**FINAL REPORT  
ROUND 10 DAM ASSESSMENT  
DAYTON POWER AND LIGHT COMPANY  
KILLEN ELECTRIC GENERATING STATION  
BOTTOM ASH POND AND FLY ASH POND**

**August 16, 2012**

Re: Round 10 Dam Assessment - Final Report  
EPA Contract No. EP10W001313  
Dayton Power and Light Company – Killen Electric Generating Station  
Bottom Ash Pond and Fly Ash Pond  
Manchester, Ohio

**FIGURE**  
**3**

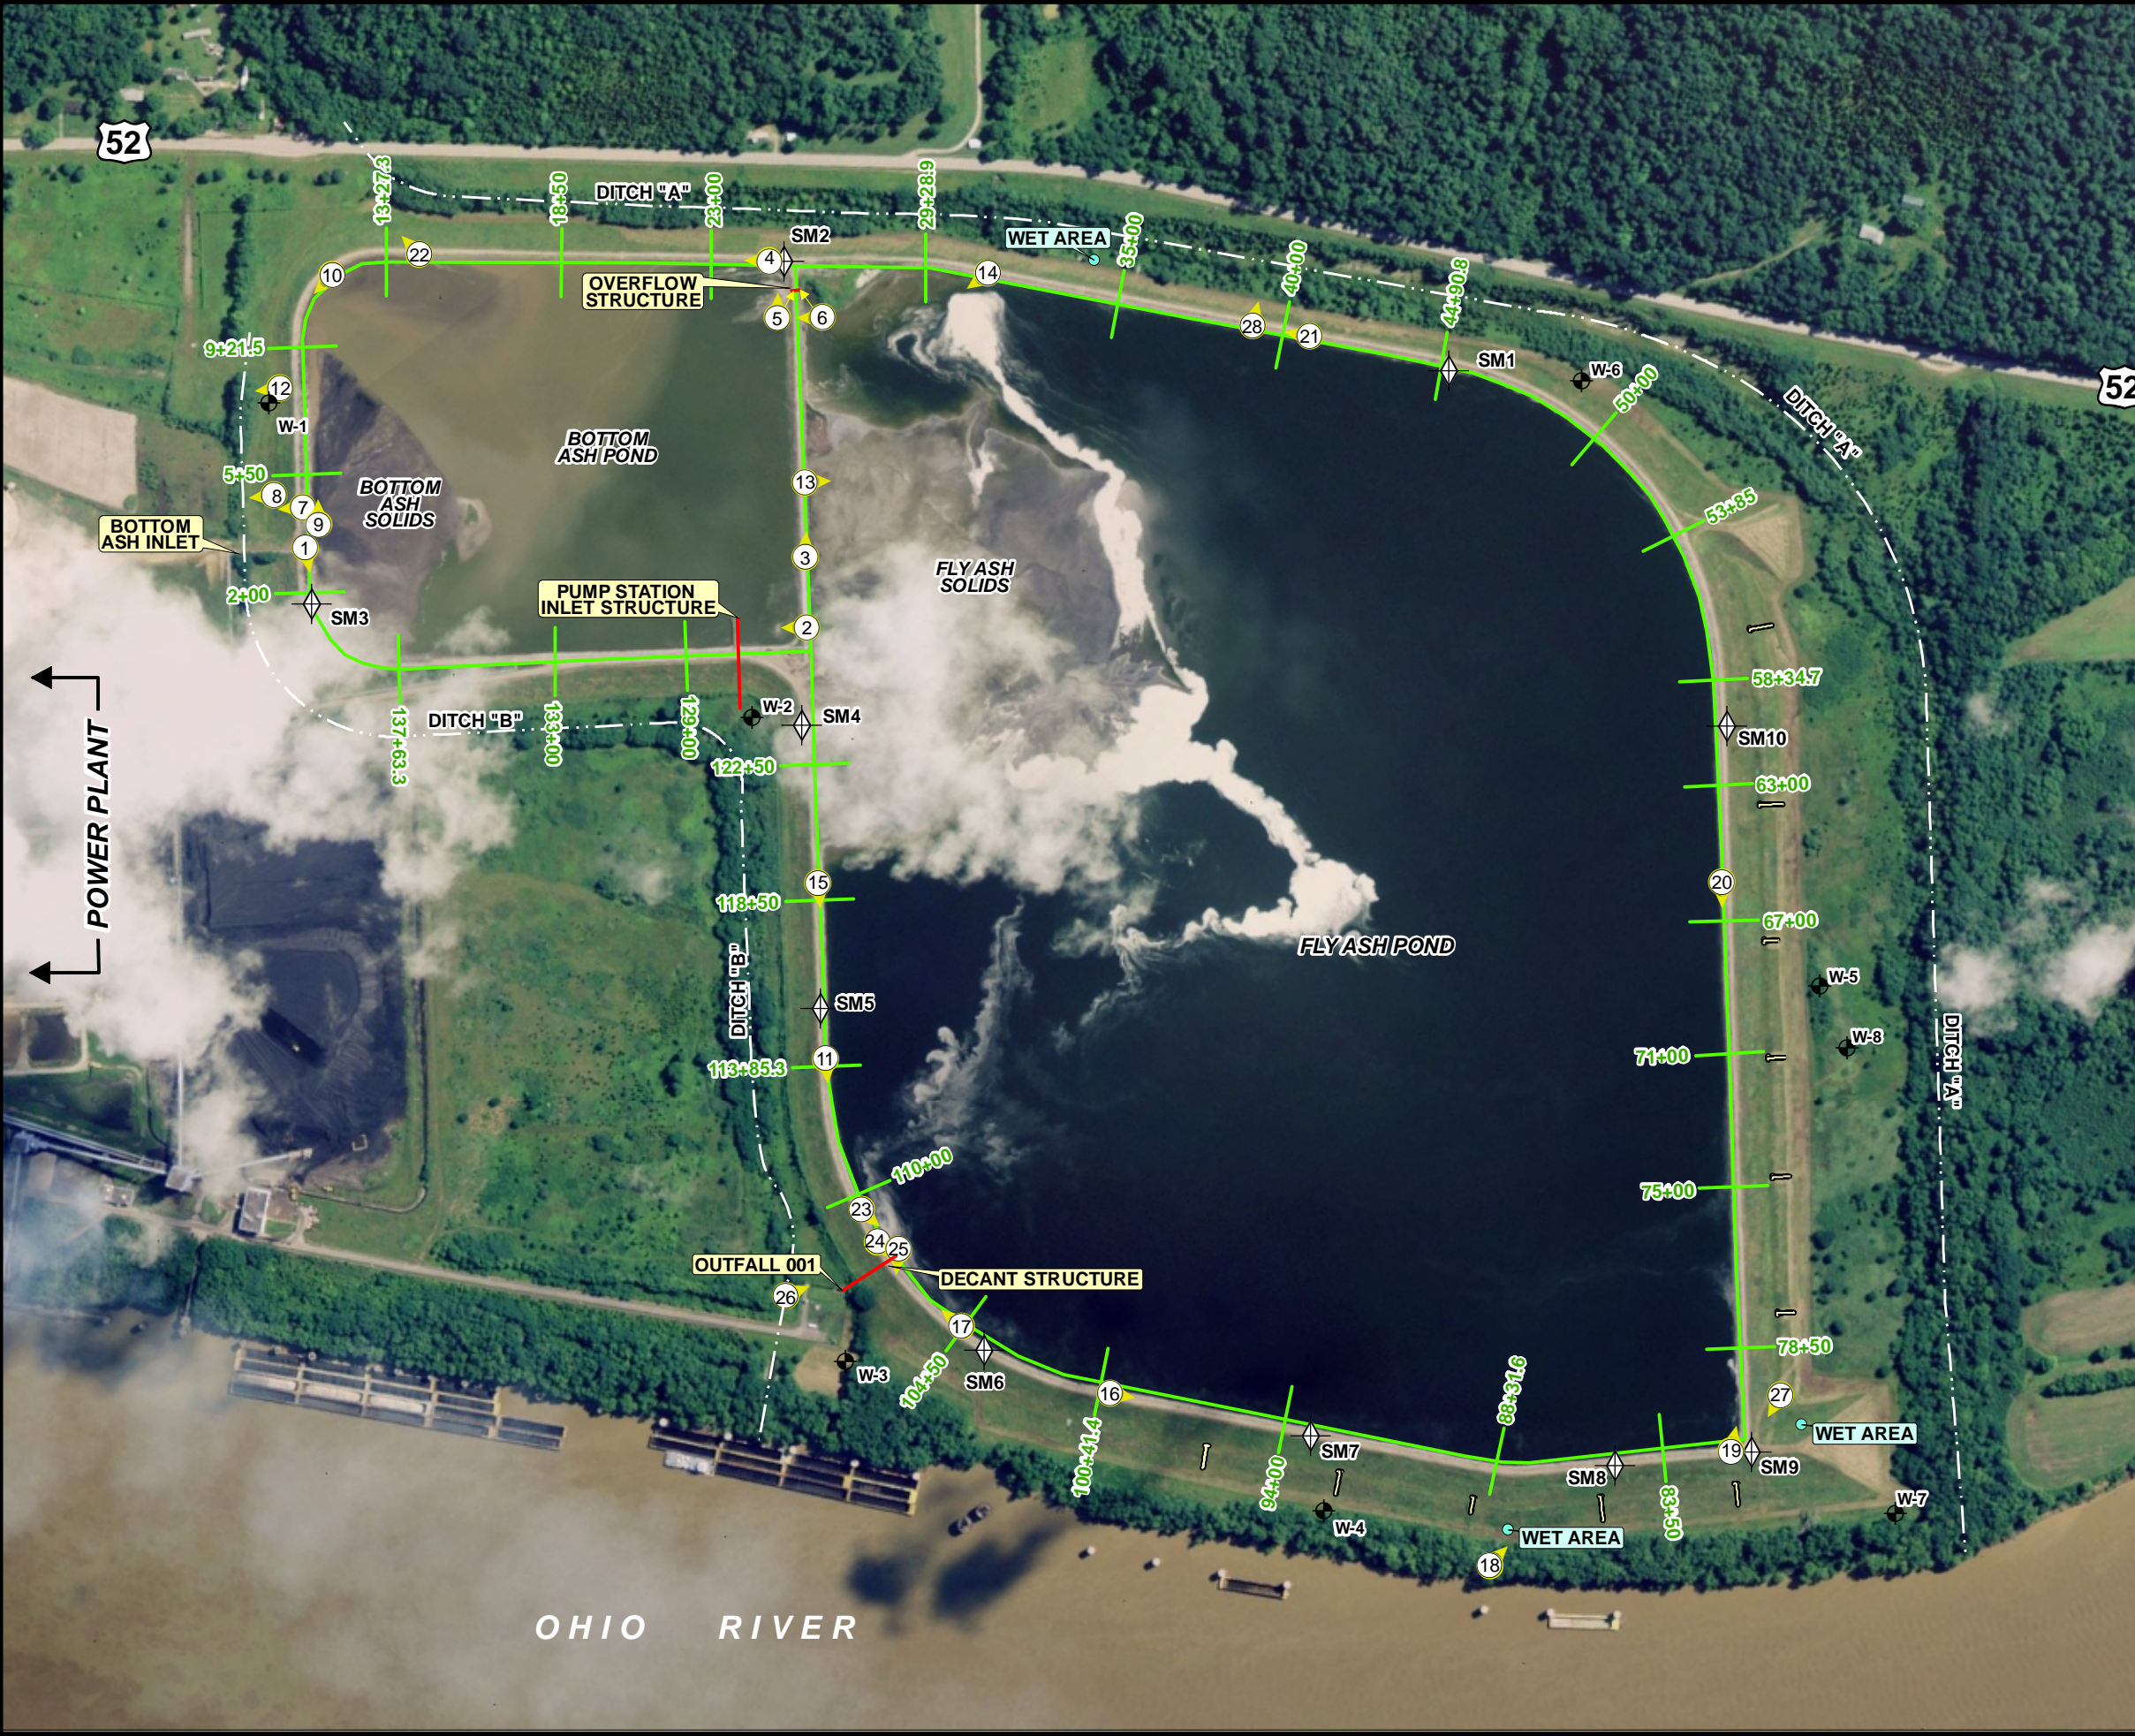
7. Limited freeboard in the vicinity of Station 3+00 to 5+00; and,
8. Reported crest and normal pool elevations indicate potential for non-compliance with state freeboard requirement of five feet for Class I dams.

The interior embankment slope generally appeared to be in good condition. As a result of the bottom ash filling operations near the Bottom Ash Inlet (**Figure 3**), the area in vicinity of Station 3+00 to 5+00 was observed to have limited freeboard (Photo 9). As of December 31, 2008, DP&L reported that approximately 1,036,074 tons of material was stored in the Bottom Ash Pond, which has an estimated capacity of 3,729,321 tons.

1. Clear vegetation from the interior embankment slopes of both ponds;
2. Remove stumps that are 4-inches or more in diameter resulting from the removal of trees and brush on the outer embankment near Station 3+00;

3. Install a staff gauge on or near the pump station inlet structure in order to take periodic measurements of the Bottom Ash Pond water surface elevation;
